**Re: Nob Hill Condos, 110 Richmond Ave SE,
Certificate of Occupancy – Transportation Development
Engineer's Stamp dated 08-06-07 (K16-D071)
Certification dated 05-14-09**

**Re: Nob Hill Condos, 110 Richmond SE,
(K-16/D071)
Approval of Permanent Certificate of Occupancy,
Engineer's Stamp Dated: 12-19-07
Engineer's Certification Date: 5-19-09**

**RE: Drainage Plan for Nob Hill Condos,
K16/D71**

110 Richmond East Alley Plan: Plan 01 7/7/2008

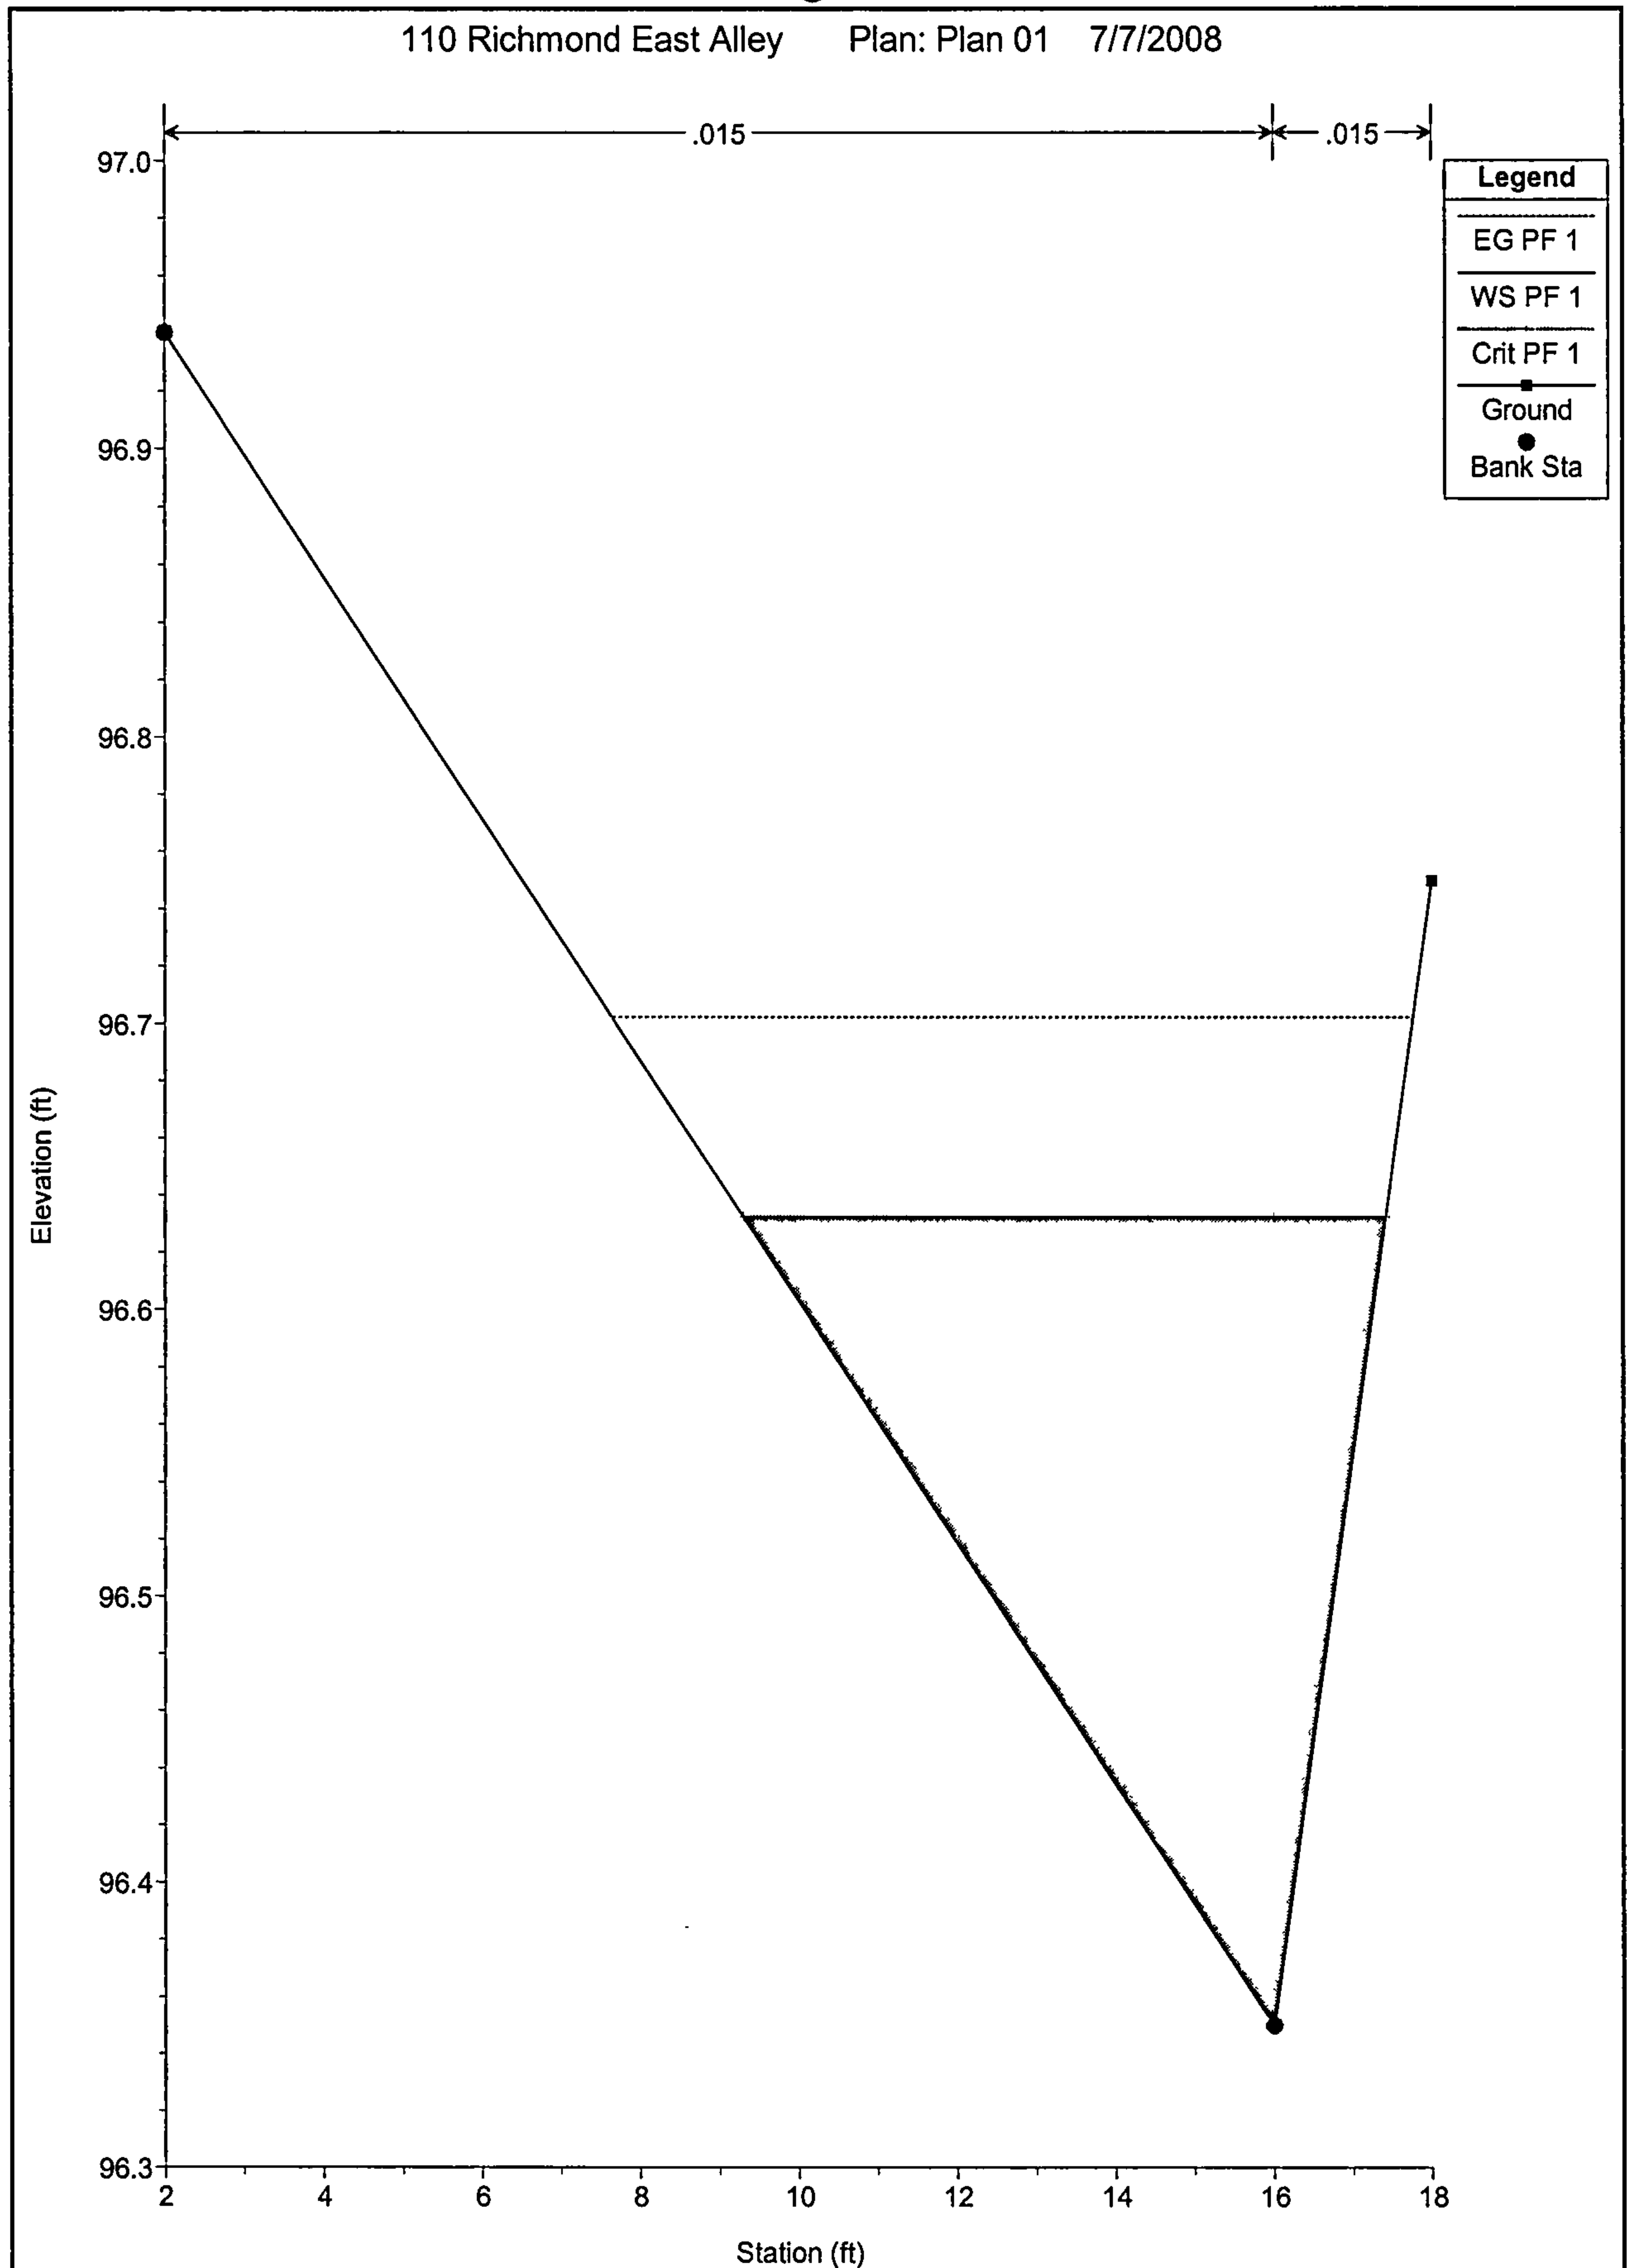
From our meeting it was decided that a couple of addition HEC-RAS sections (03 & 04, see attached) were needed about 75 feet south of the southeast corner of the subject site, behind Lot 7A, University Heights Addition (existing day care business). The attached plan is a modified version of one of the previously submitted grading and drainage plan sheets.

As suspected, our work shows that an additional 3" of paving is needed along the back of Lot 7A adjacent to the alley in order to keep flow contained within the alley during the 6-hour, 100-year storm. Our DRC Work Order Plans have been modified accordingly show this proposed work.

The additional HEC-RAS sections show we do indeed need to add a 3-inch paving section in order to contain 100-year flows in the alley and not let them escape west into the adjoining day care business. Of course typical nuisance flows should not be a problem.
